Logan-Union-Champaign regional planning commission

Zoning & Subdivision Committee

Thursday, December 14, 2017

Staff Report – Darby Braeside

L:\Projects\Projects\A-E\0320001\CAUS\SHEET504 - ROAD PLAN AND PROFILES.dwg, Last printed: 11/22/2017 2:28 PM

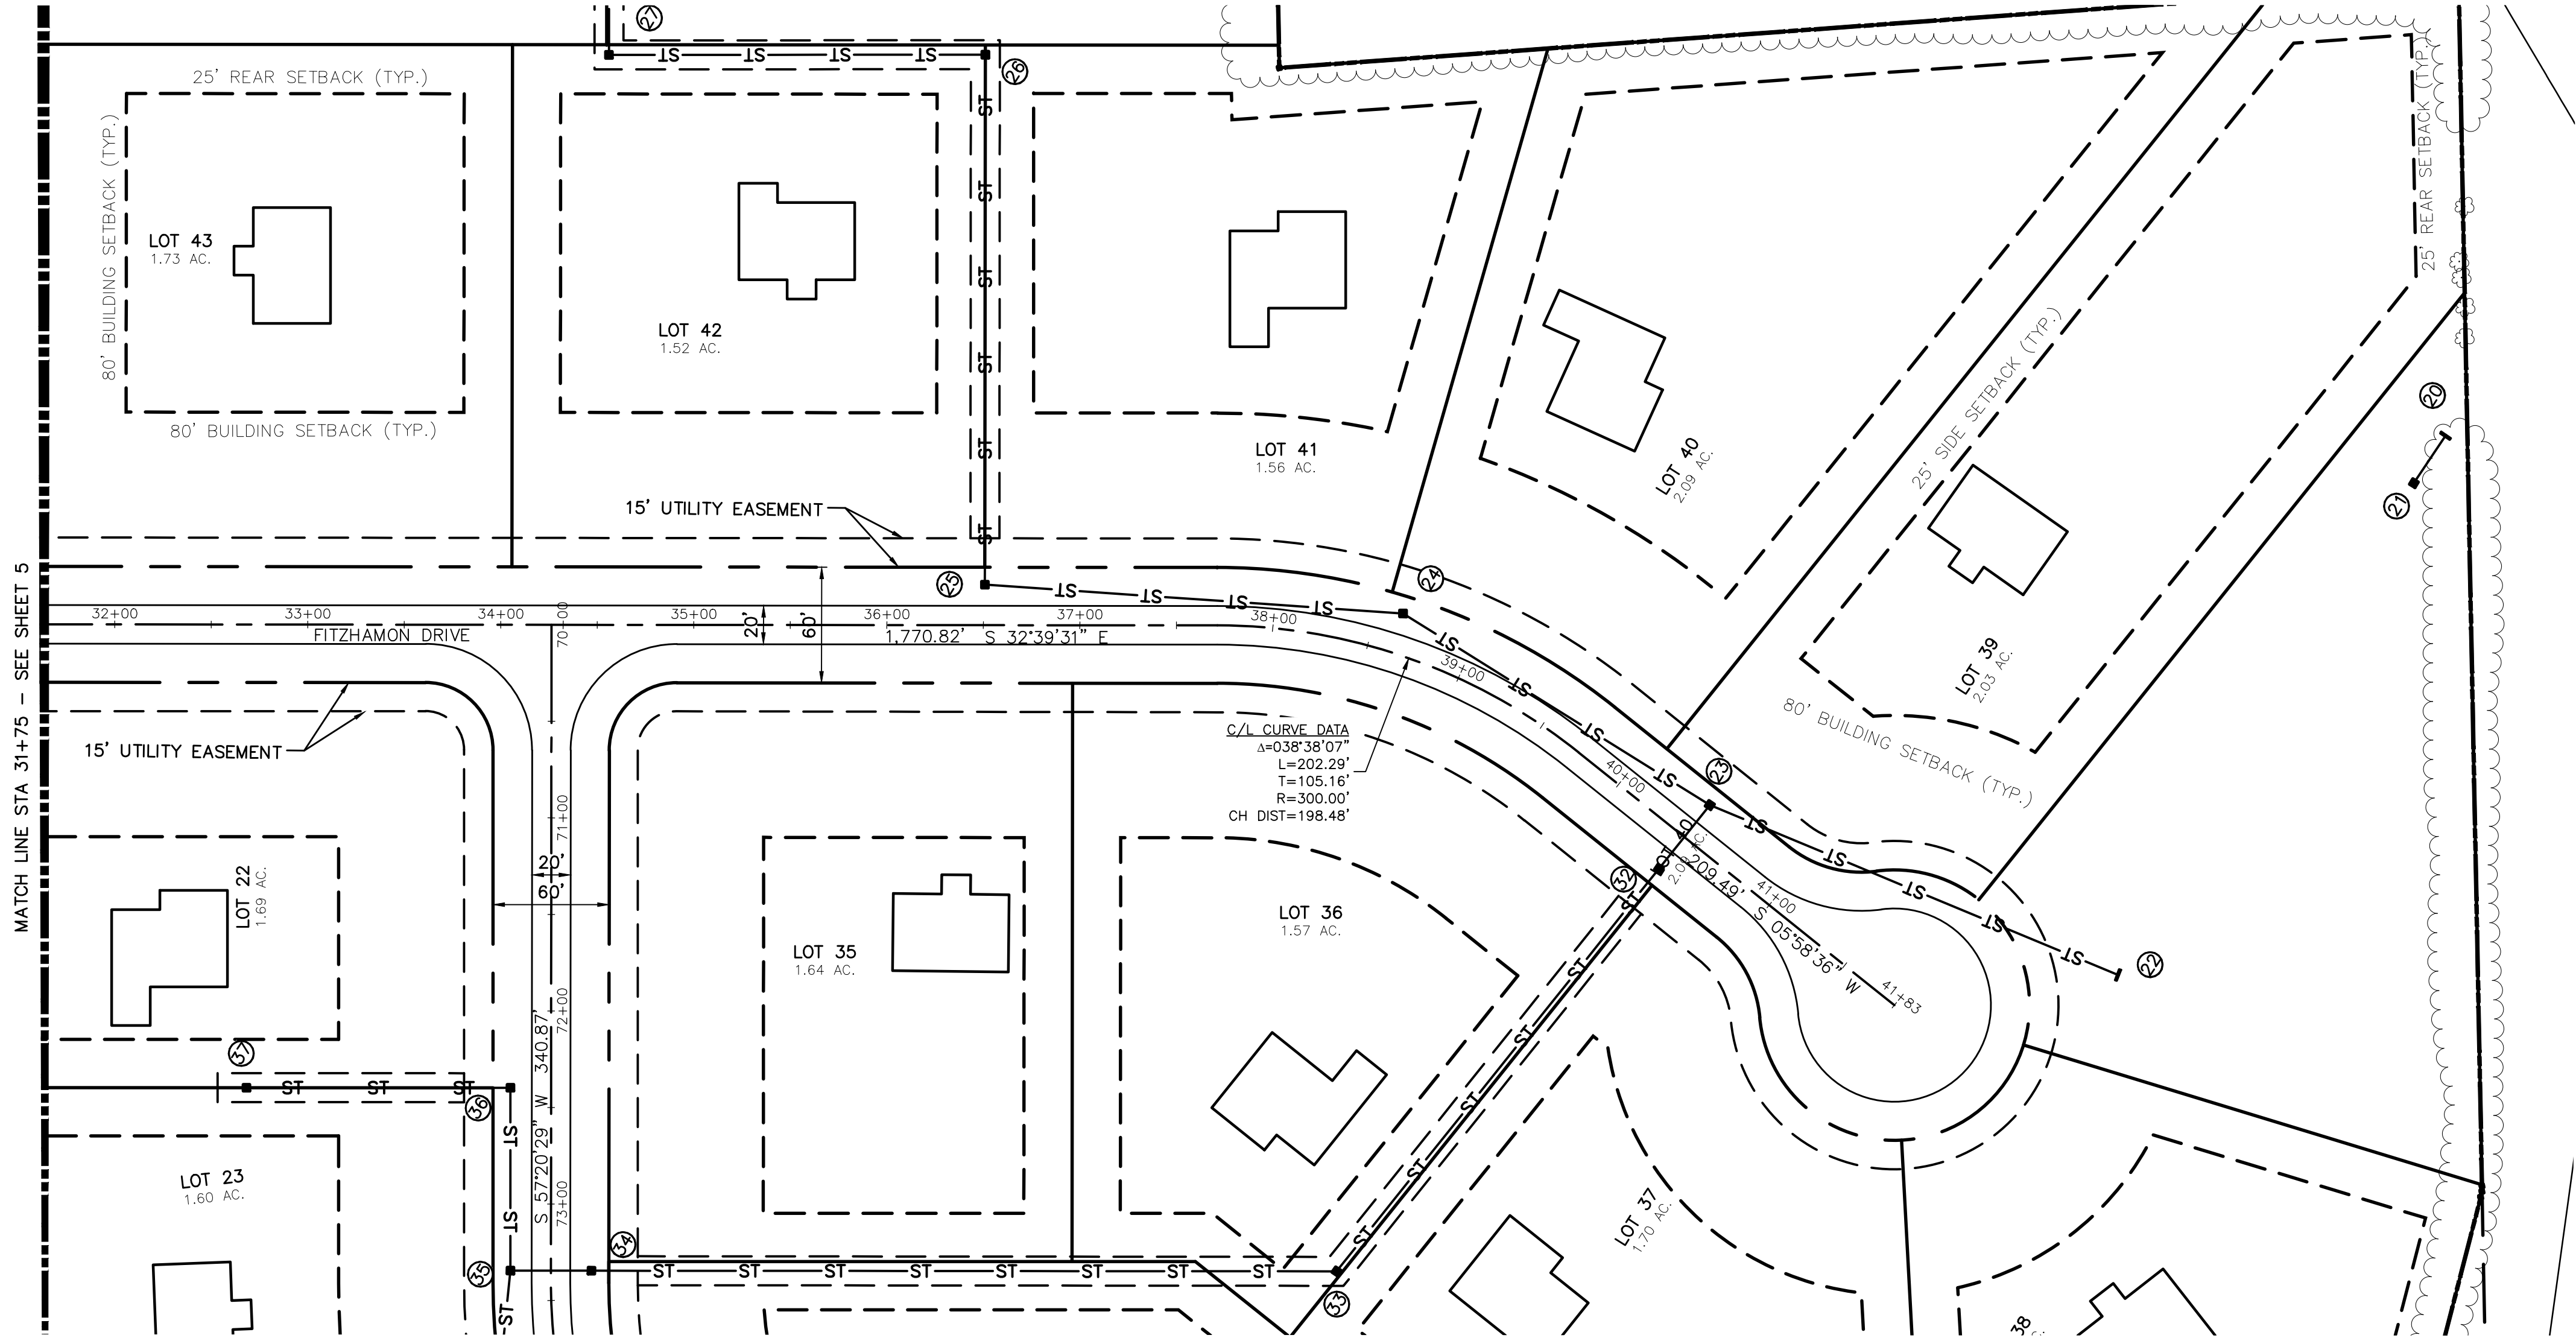
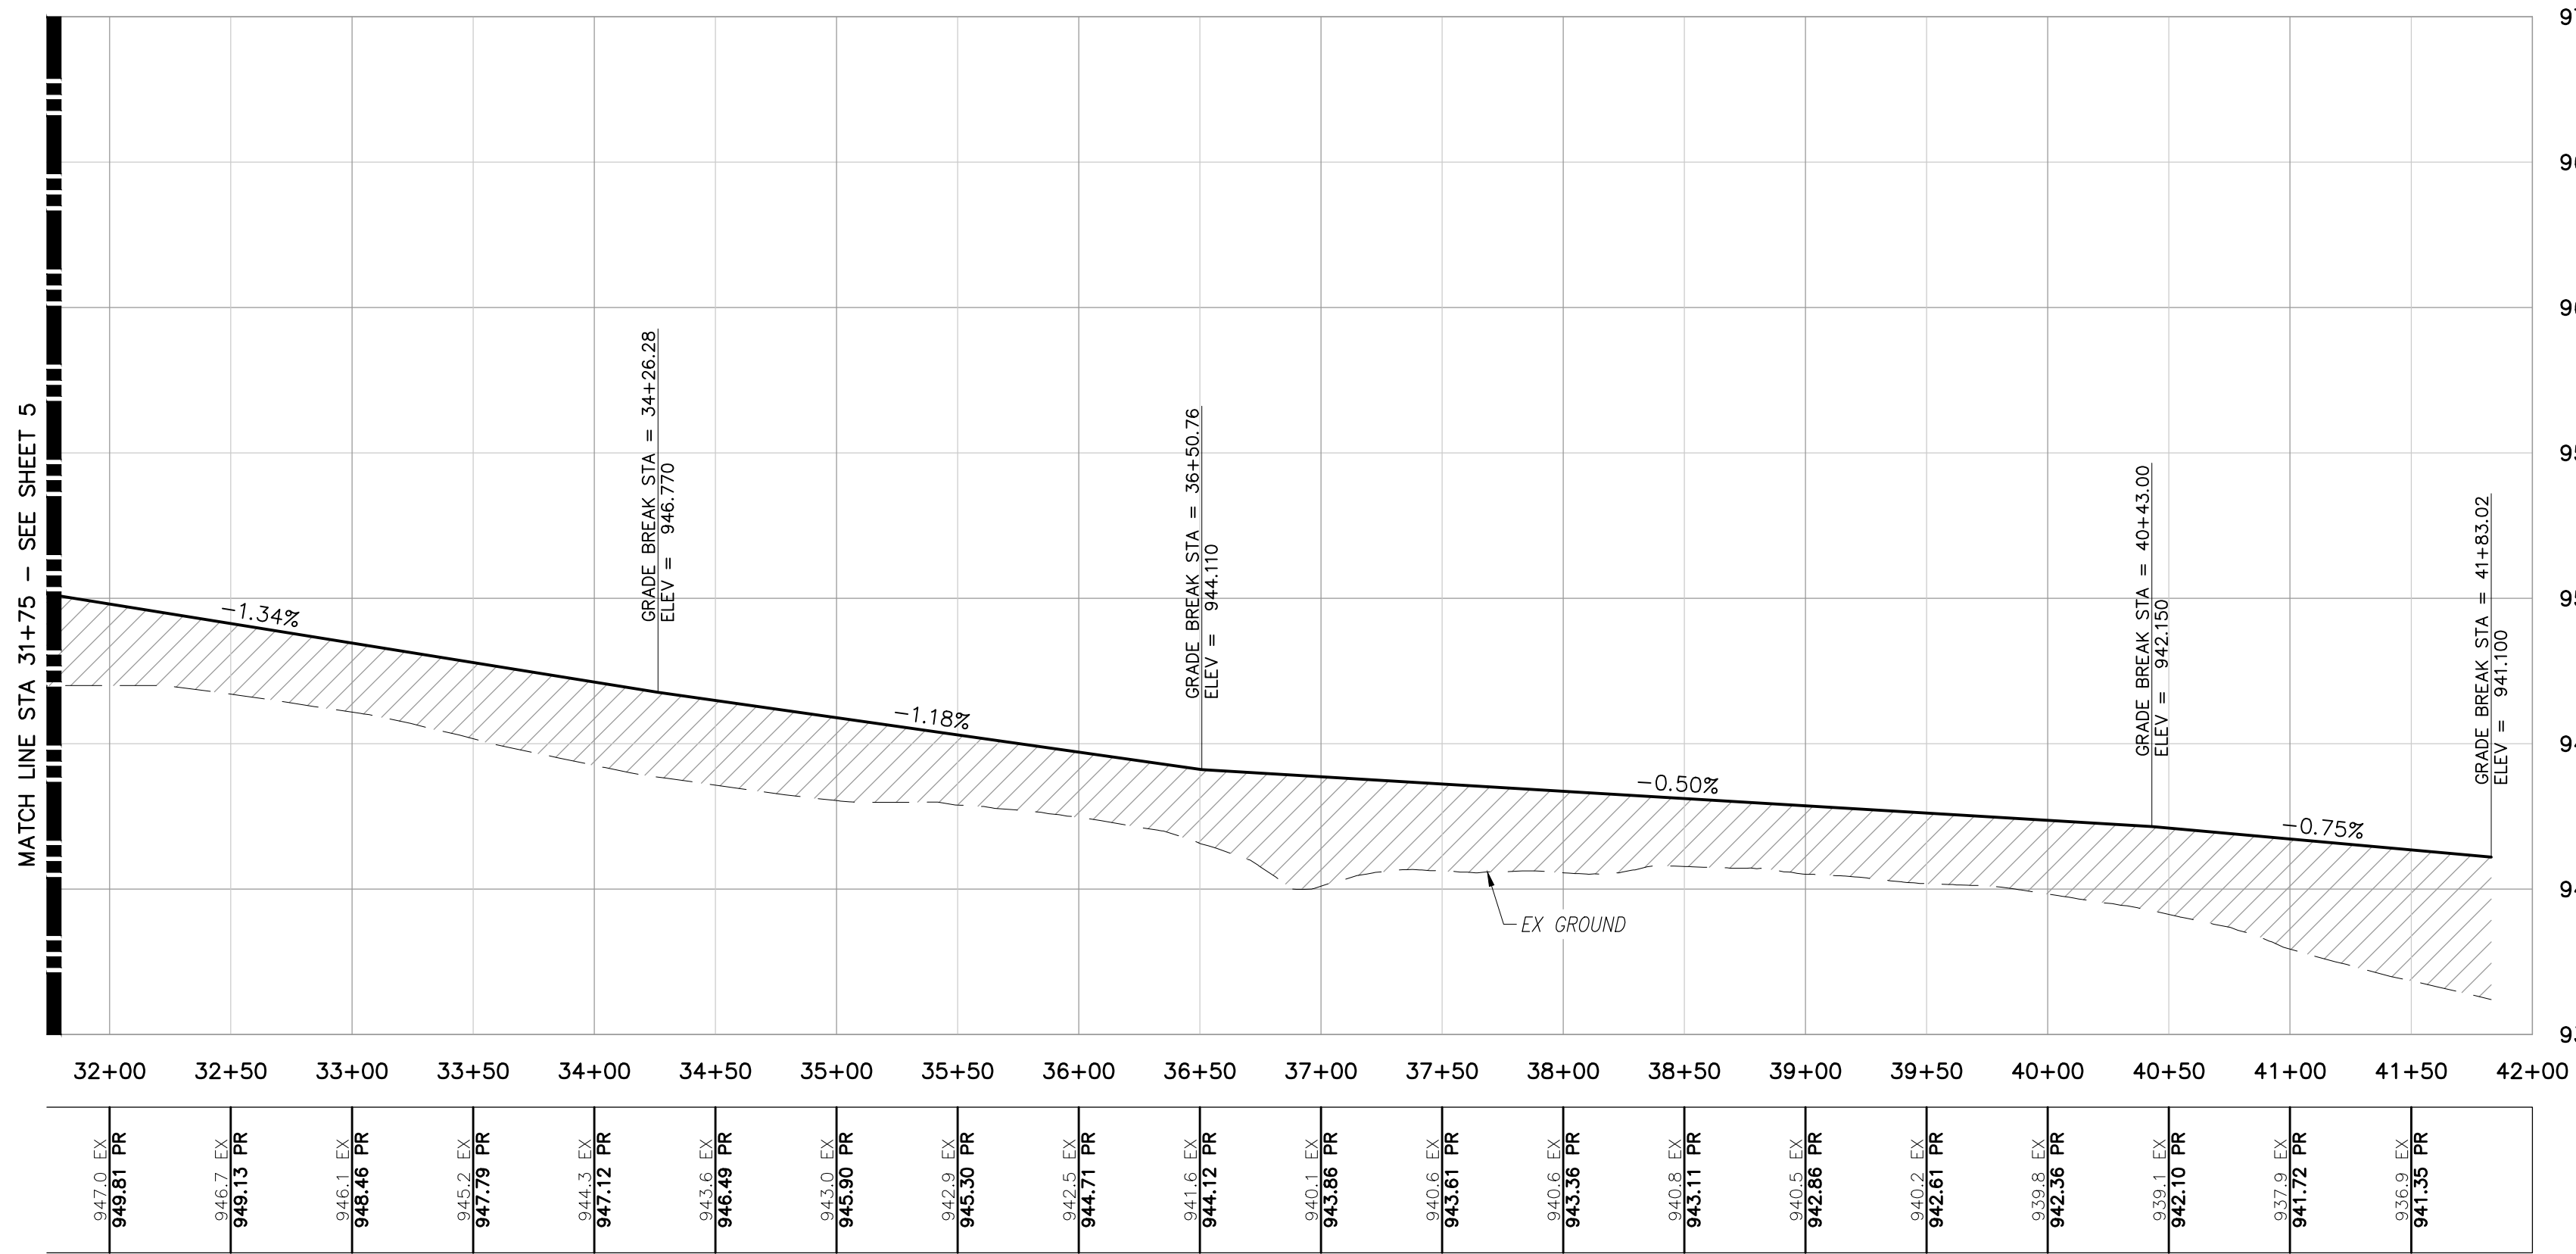
- 3) Sheet 3 of 19 – Existing Conditions
 - a) No comments
- 4) Sheet 4-8 of 19 – Roadway Plan & Profiles
 - a) URE to work with developer Engineering firm to establish offset easements between lots for primary or secondary facilities.
